UN-R127-03 **Supplement 1 proposal**

Windscreen & cowl test area clarifications (UTAC's questions)

- 1/ Windscreen: figure, third & Upper corners
- 2/ Cowl: lateral limits, third & overlap of impactors
- 3/ Jerk criteria : graph & formula

Figure 12
Windscreen test area

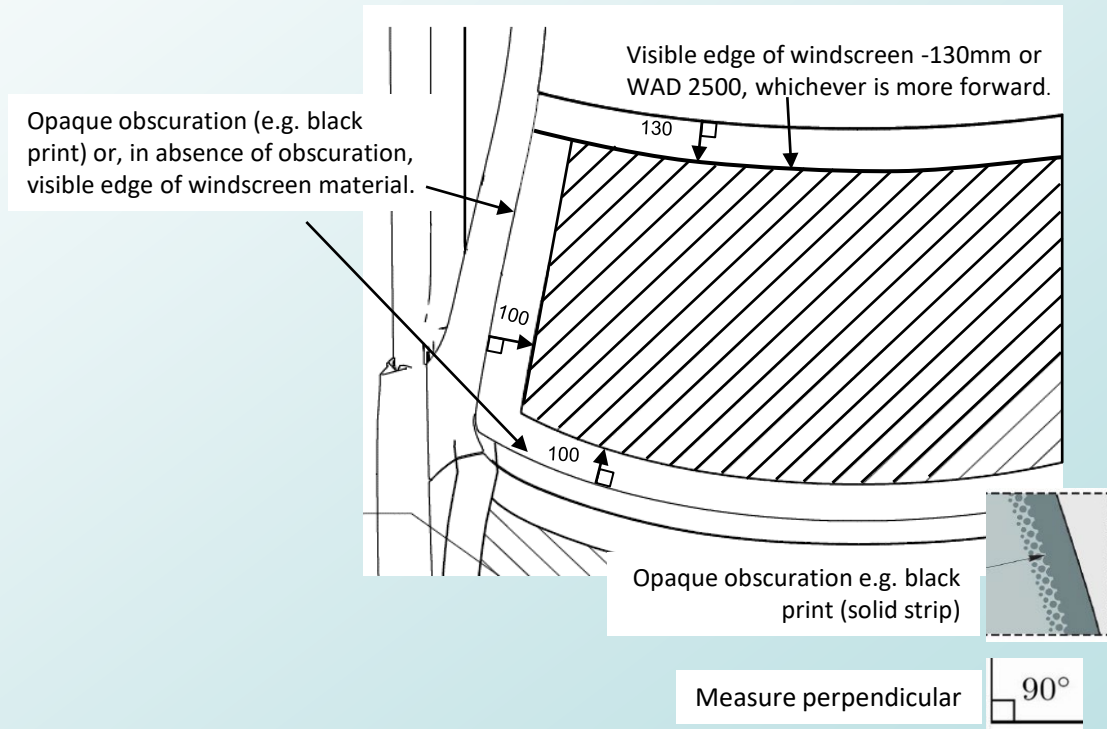
➤ Figure 12 to add in §2.44

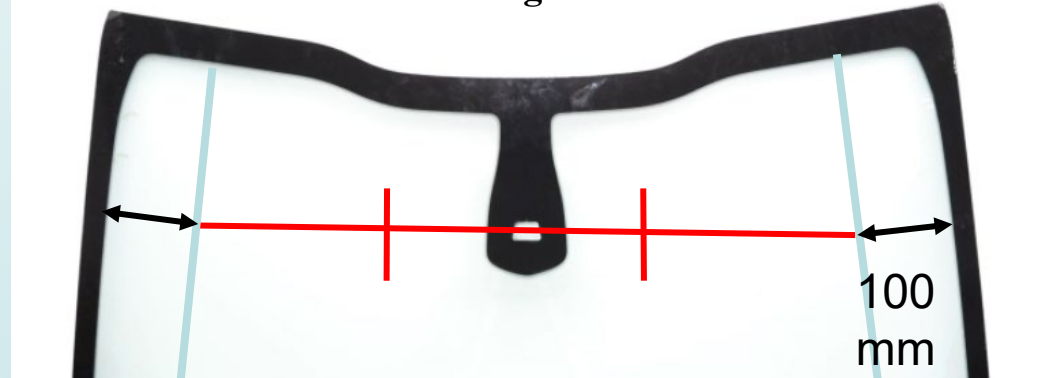
- Proposal to define the third of the windscreen:

2.49 “Third of the windscreen test area” means the geometric trace of the area between the lateral boundaries of the windscreen test area as defined in §2.44.(c), measured with a flexible tape following the outer contour of the windscreen on any transverse section, divided in three equal parts.

Figure 13

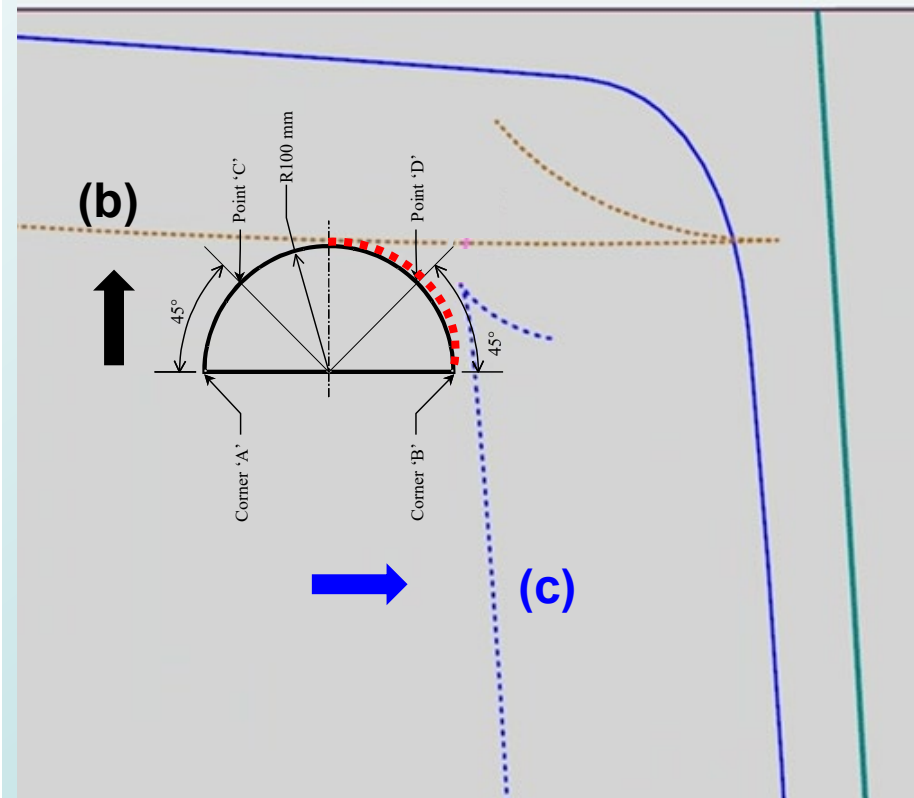
If the test area cannot be drawn, upper corners are defined by the “bonnet template”:

Where the lines defined in (b) and (c) do not intersect, they should be extended and/or modified using the semi-circular template defined in 2.8., as shown in Figure 13.

The template should be placed on the vehicle with corners “A” and “B” turned to the front of the vehicle, and Points “C” and “D” to the rear and with line AB parallel to the median transversal plane of the vehicle. The template should be slid progressively rearwards transversally until the arc of the template makes first contact with the line defined in (b).

Ensuring line AB remains parallel to the median transversal plane and first contact of the template with line defined is (b) is maintained, the template should be slid progressively transversally rearwards until the arc of the template makes first contact with the line defined in (c). Throughout the process, the template should be curved to follow, as closely as possible, the outer contour of the vehicle's windscreen, without wrinkling or folding of the template. Then the contour of windscreen test area is extended and/or modified to follow the circumferential arc of the template to meet the line defined in (c), as shown in Figure 13.

If the template cannot make simultaneous contact with lines defined in (b) and (c), then additional templates should be used where the radii are increased progressively in increments of 20 mm, until simultaneous contact with lines defined in (b) and (c) are achieved.

Figure 14:
lateral limits of the cowl monitoring area

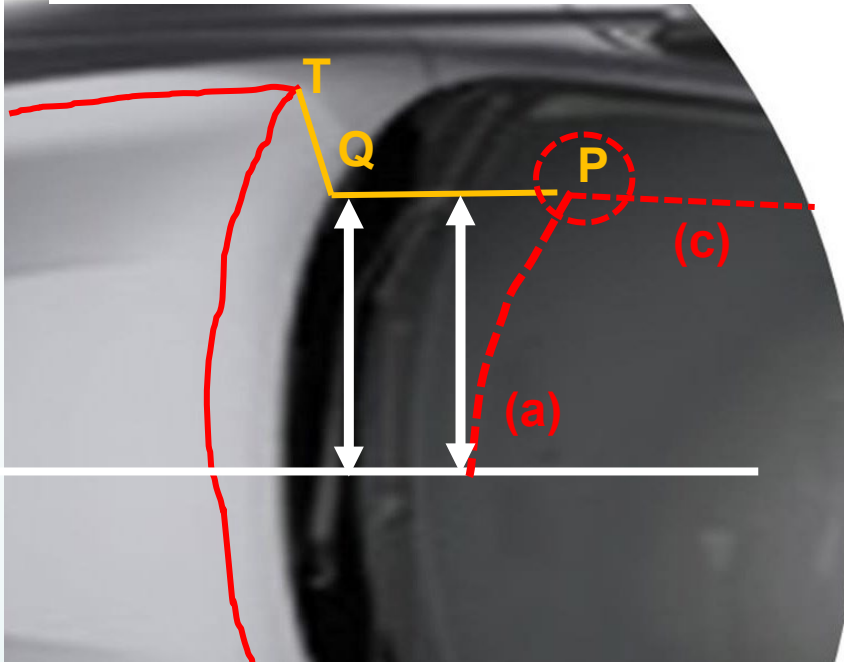
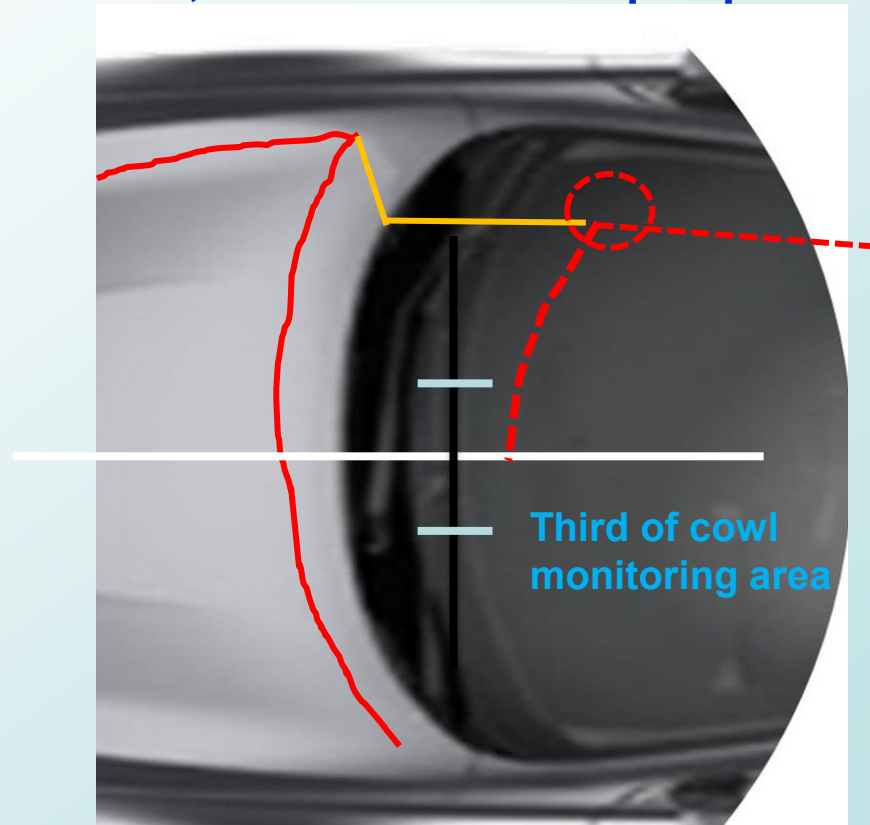
➤ Proposal to define the cowl lateral limits:

In order to generate the lateral boundary of the cowl monitoring area (see Figure 14), at each side:

- the “P corner point” will be projected forward to the rear edge of the bonnet top and create Q point;
 - the Q point will be connected to the “T point” (rear corner of the bonnet top test area);
- using a flexible tape held tautly from point P to Q and on the outer surface of the vehicle from point Q to T.

Figure 16: Jerk criteria graph and formula

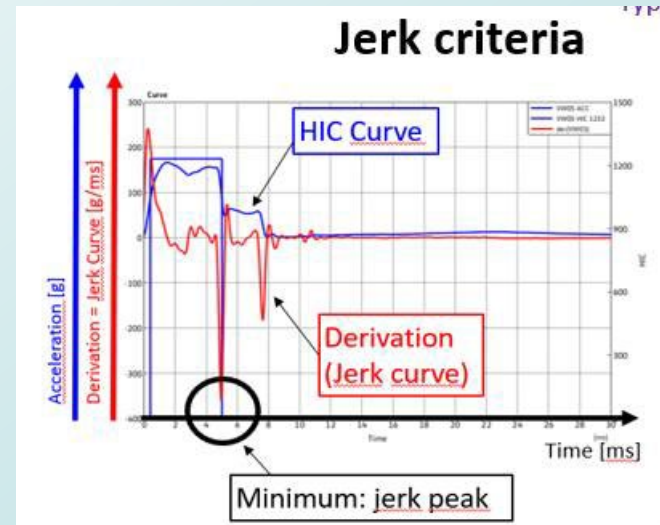
Add following formula and figure to § 2.48.

- (a) The absolute value of the minimum value of the derivation of the headform acceleration versus time is below 180 g/ms for the first 4 ms after the initial contact of the headform to the windscreen, **as shown in Figure 16** ; or

$$\left| \min \left(\frac{da}{dt} \right) \right| < 180 \text{g/ms, for } 0 < t < 4 \text{ms}$$

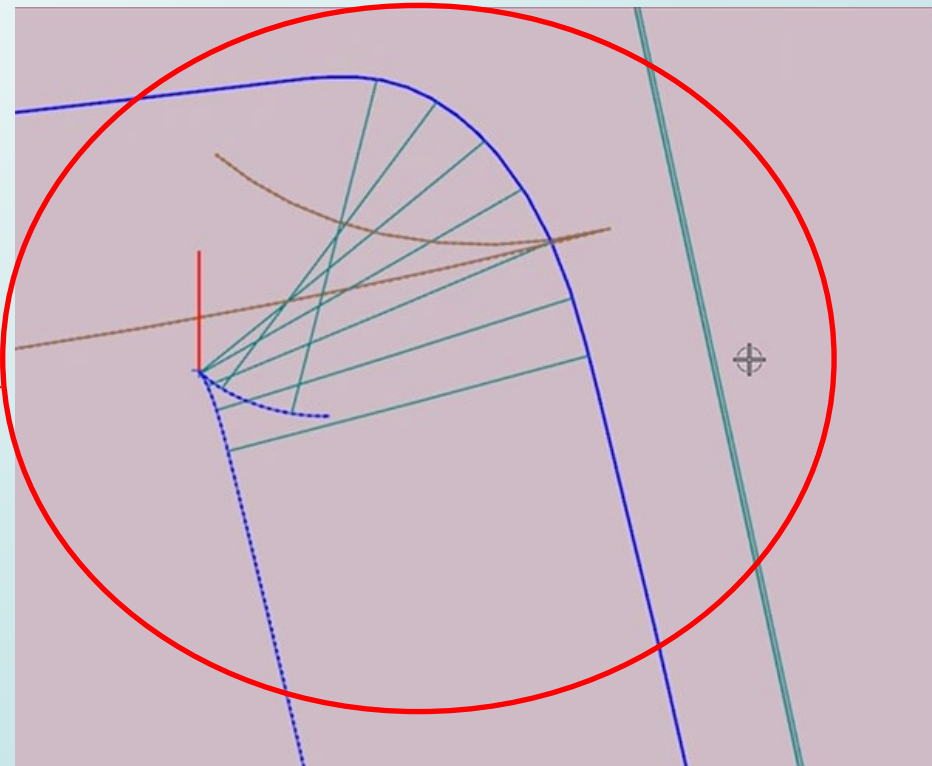
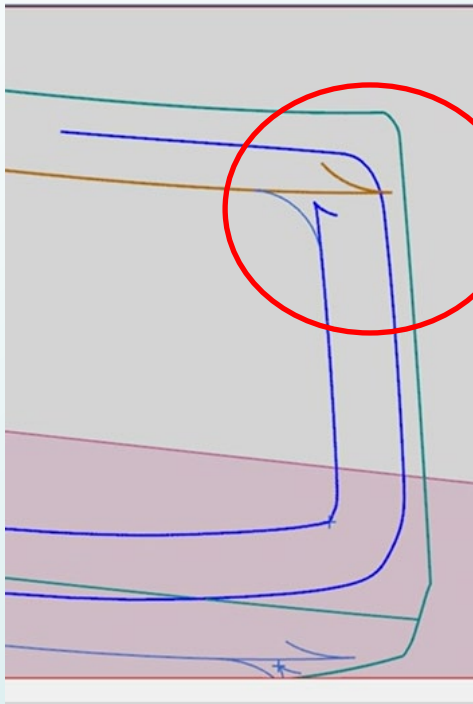
Problem: no “corner”

Splines are 90° offset from

- Side blackprint → blue side limit
- Rear visible edge → brown rear limit

=> **With 2 “hook shapes” which do not intersect.**

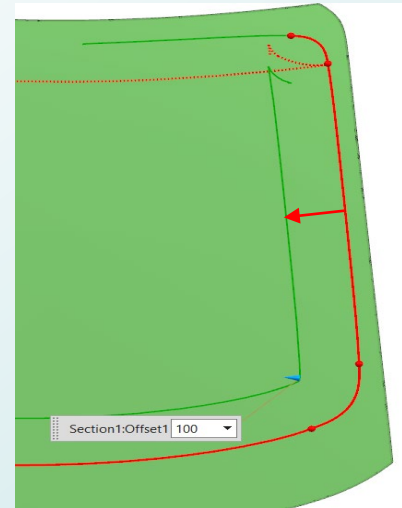
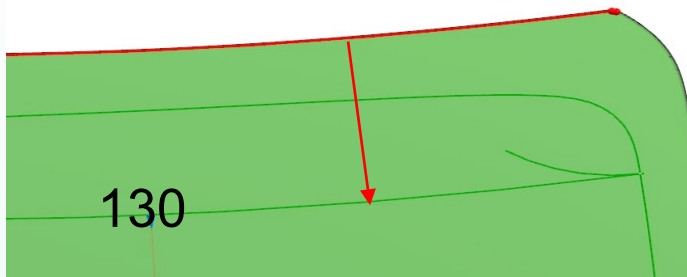
Notice how splines are giving a different type of offset feedback when offset 90° to spline

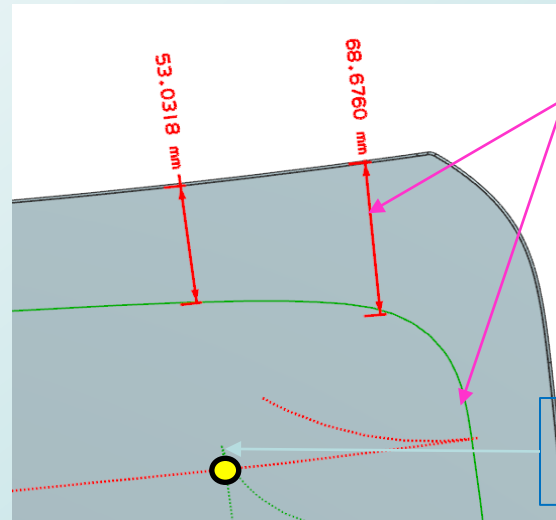
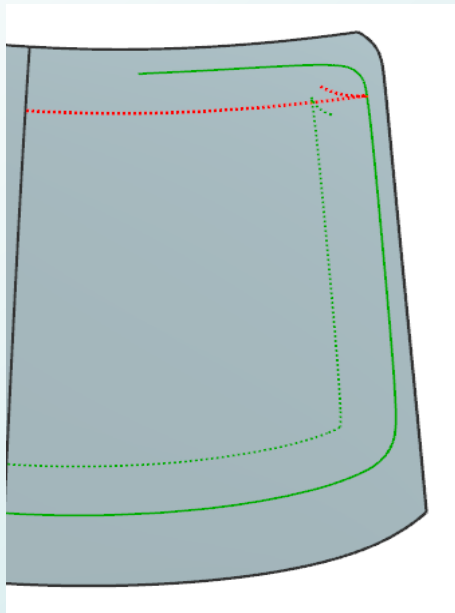
Highly dependent on how far forward the blackout starts from the rear edge of glass, how far down the side the corner arc (spline) reaches, and radius of corner arc

Small overlap for intersection - Potential for no intersection
